Preliminary & Final Drainage Report
for
Rex Road
through
Falcon Regional Park

MERIDIAN RANCH
A GOLF & RECREATIONAL COMMUNITY

EL PASO COUNTY, COLORADO

February 2023

FIGURE 6

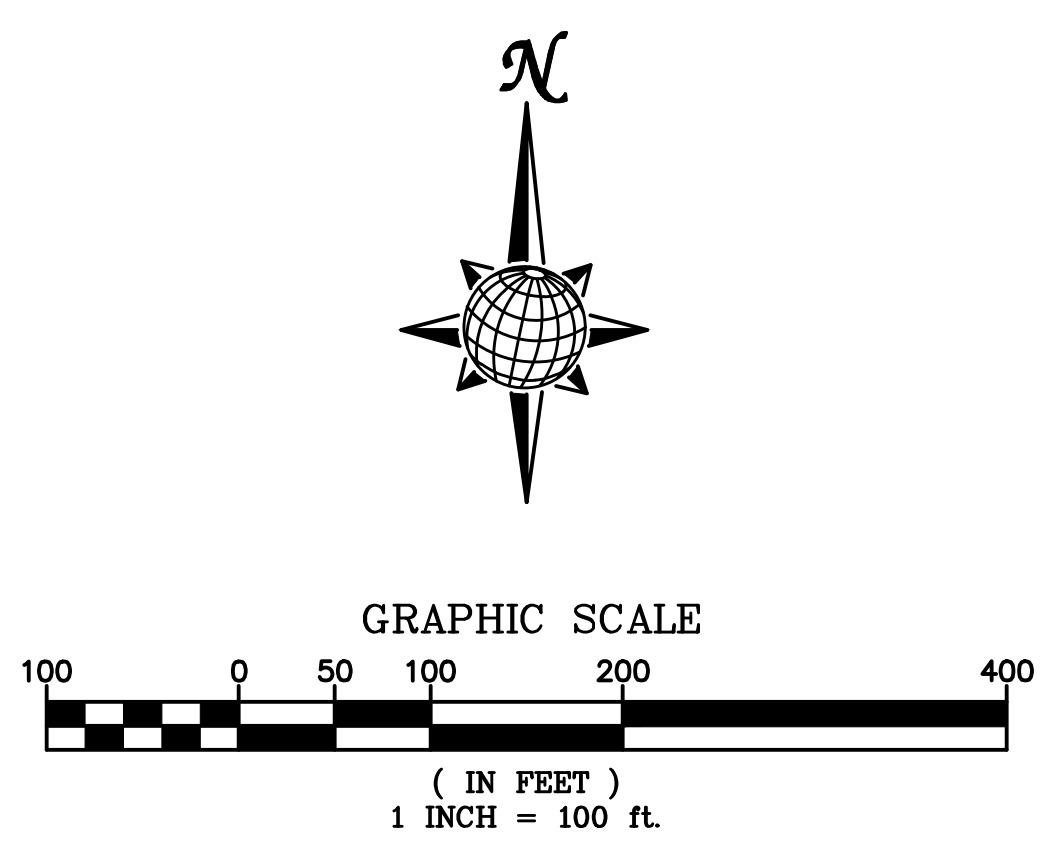
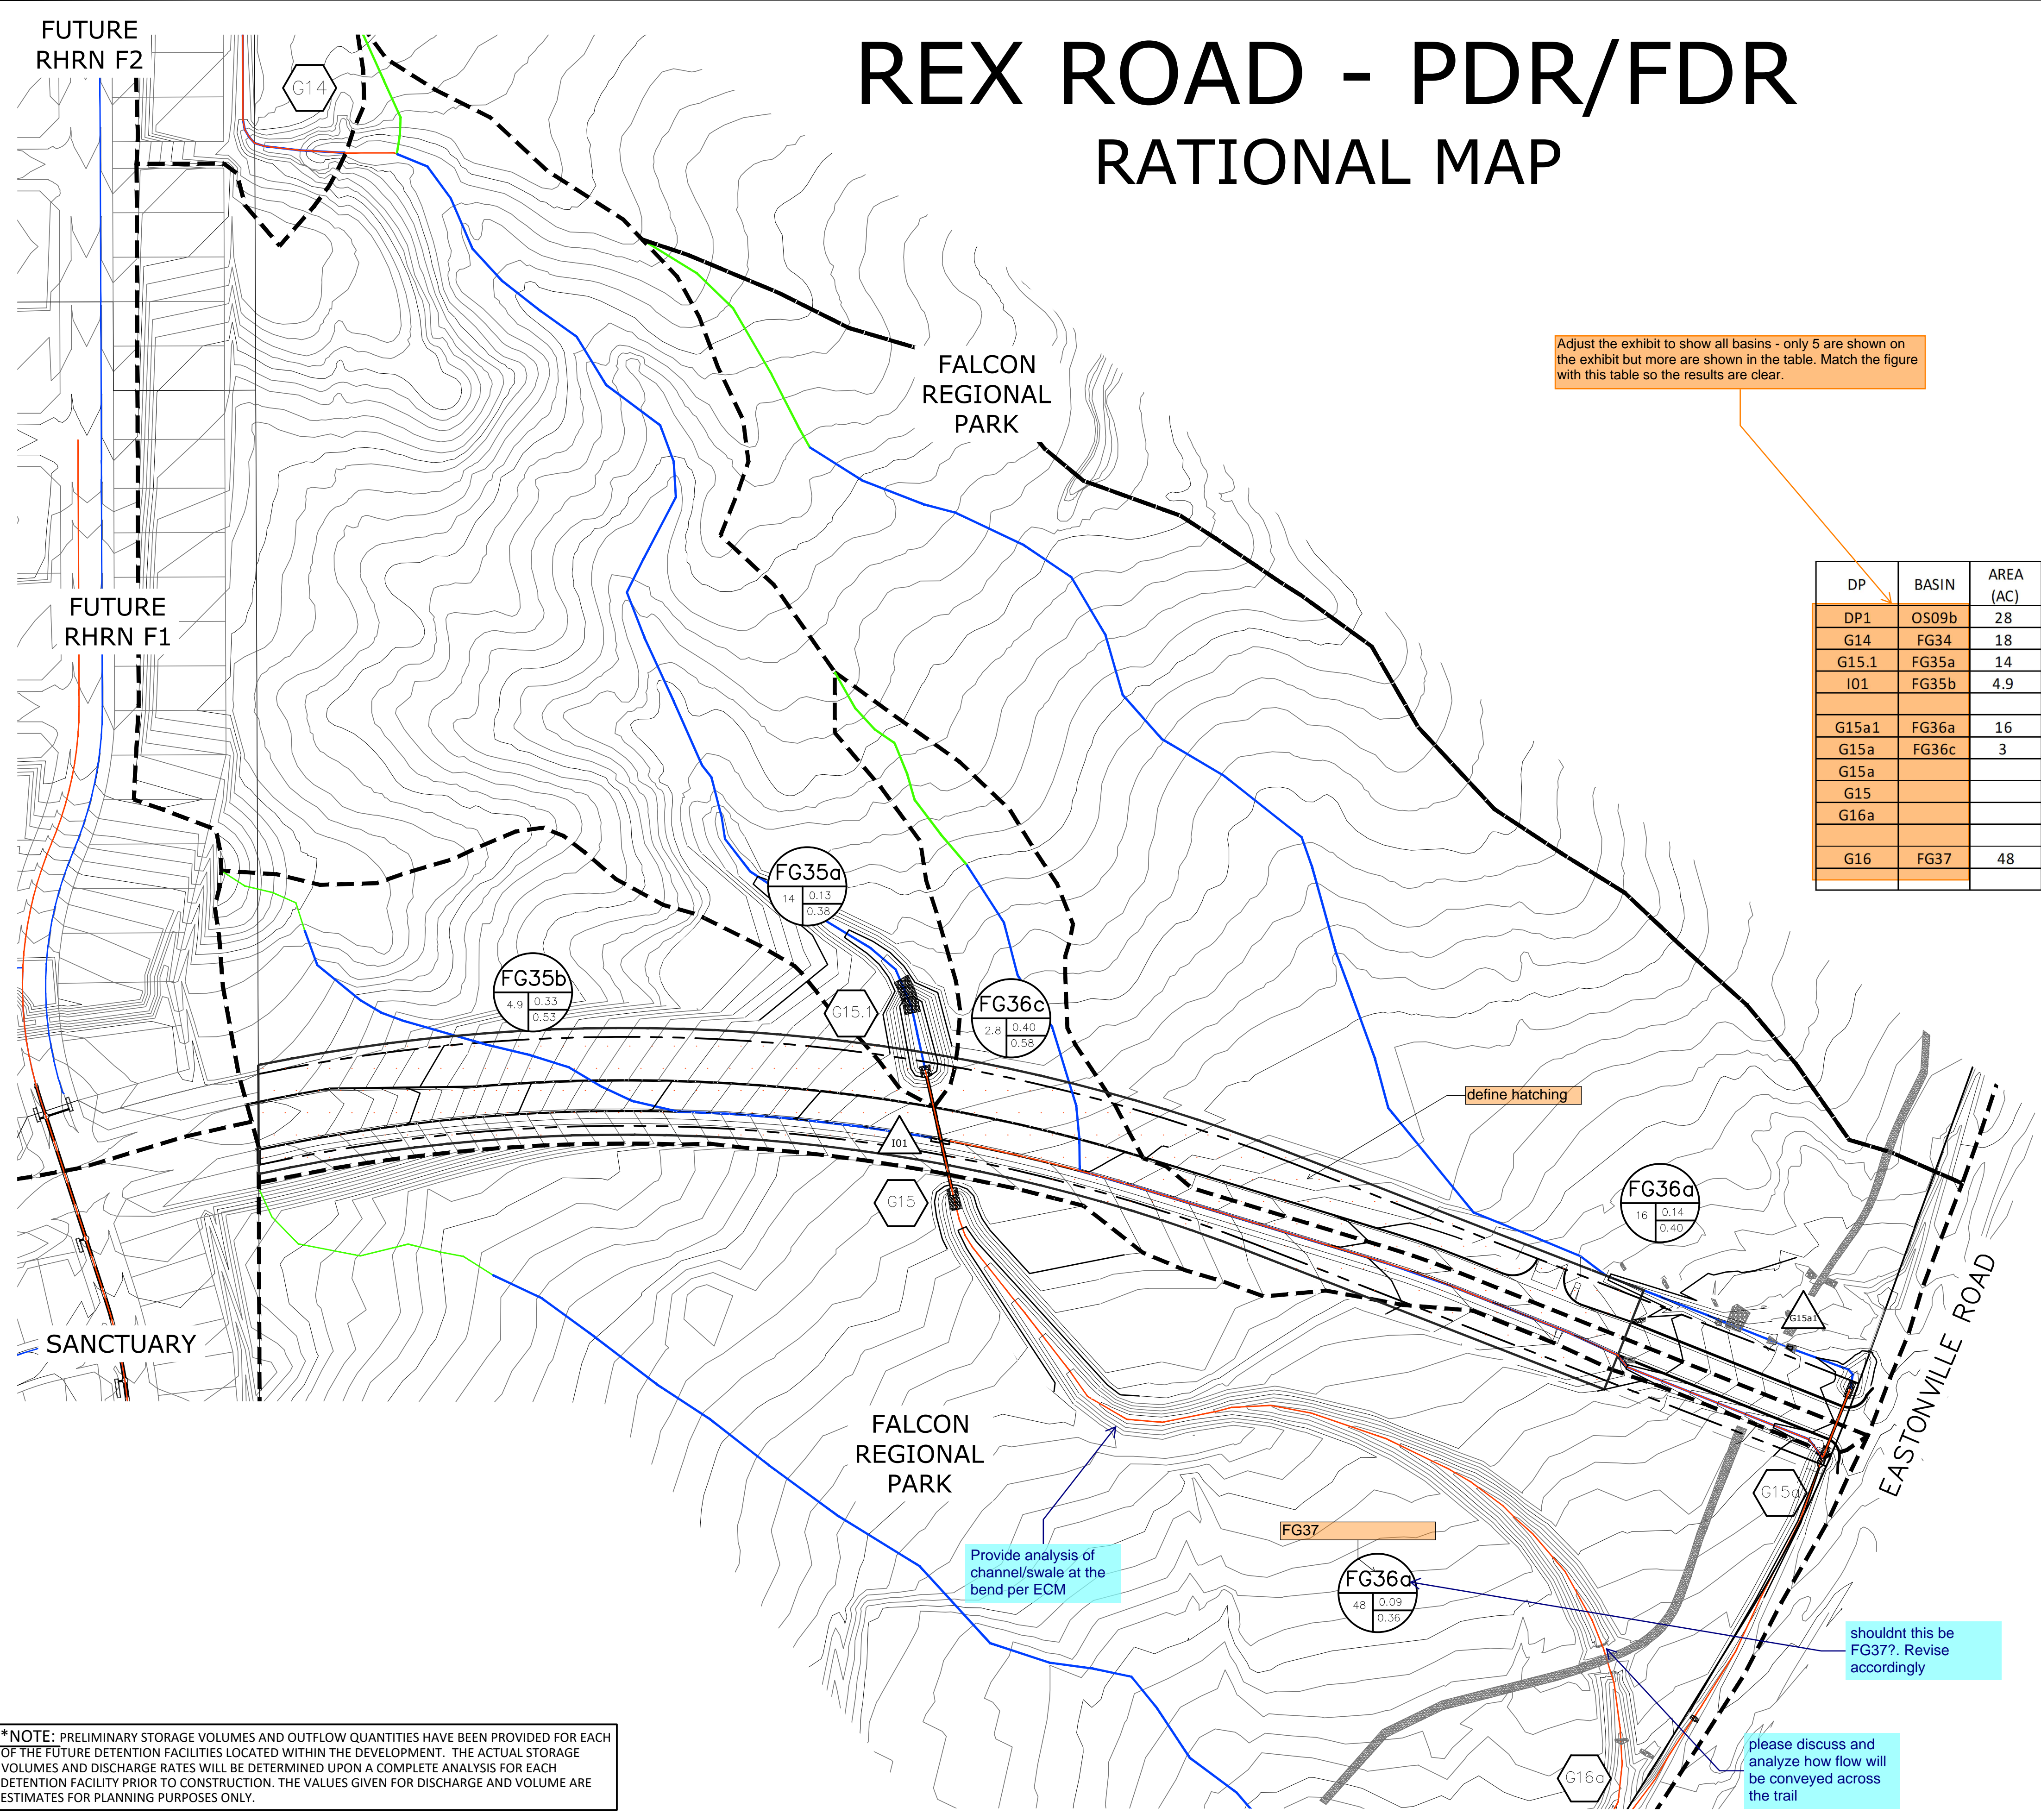
Adjust the exhibit to show all basins - only 5 are shown on the exhibit but more are shown in the table. Match the figure with this table so the results are clear.

Please clarify as the narrative indicates that flows at G14 are less than historic peak discharge of 38 cfs

Please discuss & analyze this 24" storm pipe in the report and label it on the drainage plan

Provide analysis of channel/swale at the bend per ECM

shouldnt this be FG37?. Revise accordingly
